Statement

MAXON MX5010
FCC ID: AWWMX5010

Battery GDX2002

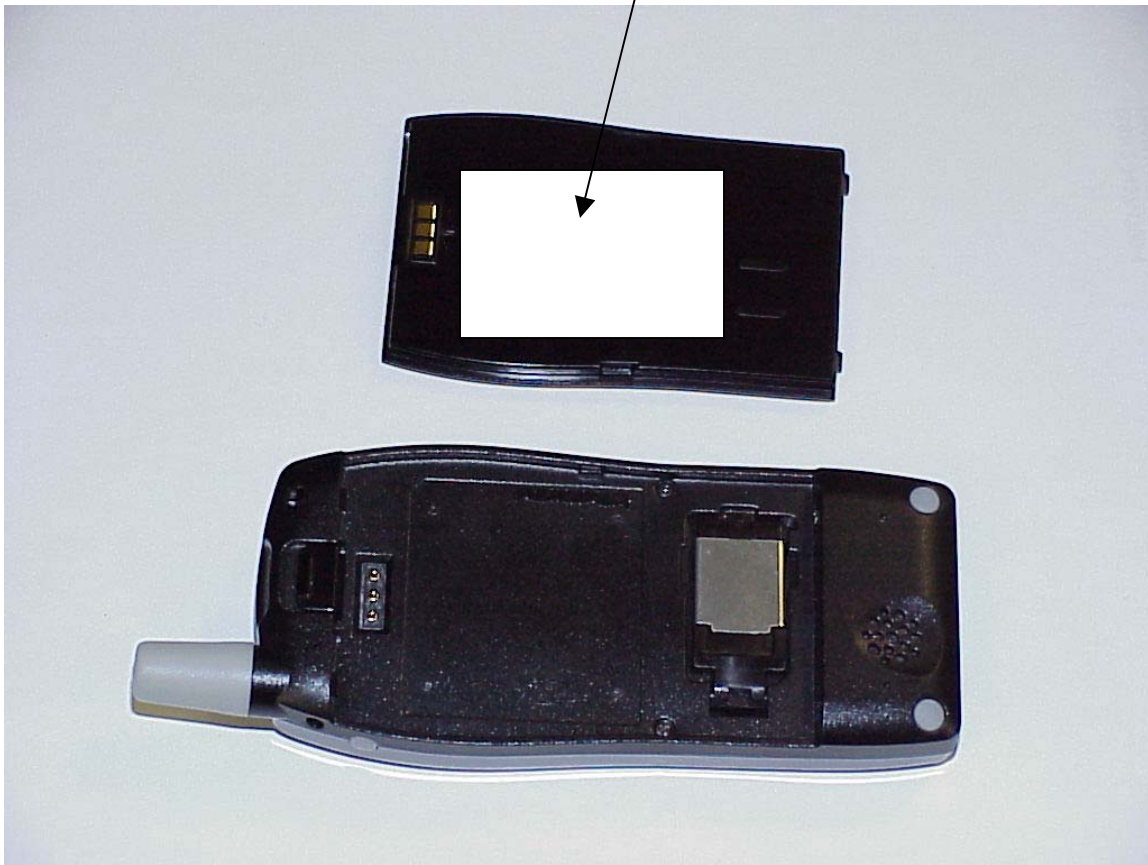
Battery itself is identical only the plastics around is adopted for design reasons. Location of the real battery.

The battery plastics follows now the shape of the phone were it was an rectangular insert in the previous version.
